Access Compliance Report

(Curb Ramps)

Intersection ID: N/A	Main Street: LUTHER_ST	Cross Street: QUEENS_RD	Location: NW
ADA ID: FBB1FD91E2E8	Ramp Type: Perp	Initial Pass/Fail: Fail	Overall Compliance: No
Severity Score: 35			
Codes/Mitigation Info/Possible Solution		Field Measurements/Component Compliance

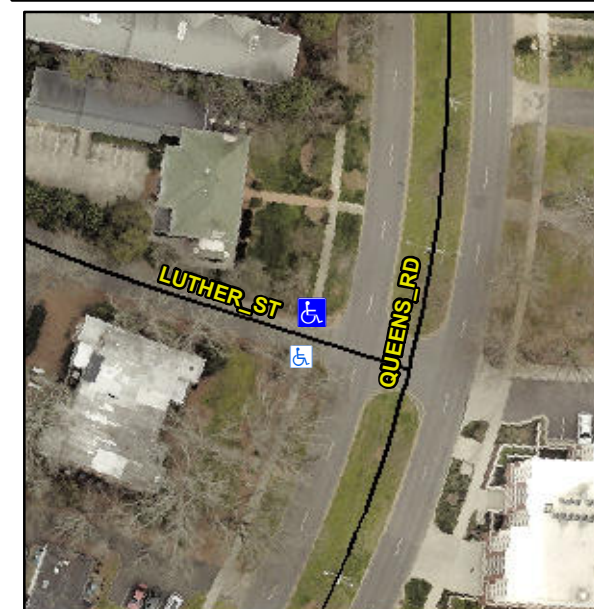
Not Found, R304.5.1, R304.2.2, R304.5.3

Compliance	Description	Data	Compliance	Description	Data
N/A	Ramp Length (in)	43.0	No	Ramp Slope (%)	15.2
No	Ramp Width (in)	36.0	No	Ramp XSlope (%)	3.7
N/A	Flare Type LT	N/A	N/A	Flare Type RT	N/A
N/A	Flare Slope LT (%)	N/A	N/A	Flare Slope RT (%)	N/A
N/A	Flare Traversable LT?	N/A	N/A	Flare Traversable RT?	N/A
N/A	Landing Length (in)	N/A	N/A	DWS Provided?	N/A
N/A	Landing Width (in)	N/A	N/A	DWS Contrast?	N/A
N/A	Landing Slope (%)	N/A	N/A	DWS Length (in)	N/A
N/A	Landing X Slope (%)	N/A	N/A	DWS Full Width?	N/A
N/A	Landing Curb? (Y/N)	N/A	N/A	DWS Offset (in)	N/A
N/A	Shared Landing?	N/A			
N/A	Gutter Ponding?	N/A	N/A	Gutter Slope (%)	N/A
N/A	Gutter Lip Ht (in)	N/A	N/A	Gutter X Slope (%)	N/A
N/A	Painted X Walk1?	No	N/A	Painted X Walk2?	N/A
	X Walk 1 Direction	To SW		X Walk 2 Direction	N/A
N/A	X Walk 1 Width (in)	N/A	N/A	X Walk 2 Width (in)	N/A
	X Walk 1 Slope (%)	2.1		X Walk 2 Slope (%)	N/A
	X Walk 1 X Slope (%)	3.2		X Walk 2 X Slope (%)	N/A

Remove & Replace Entire Ramp.
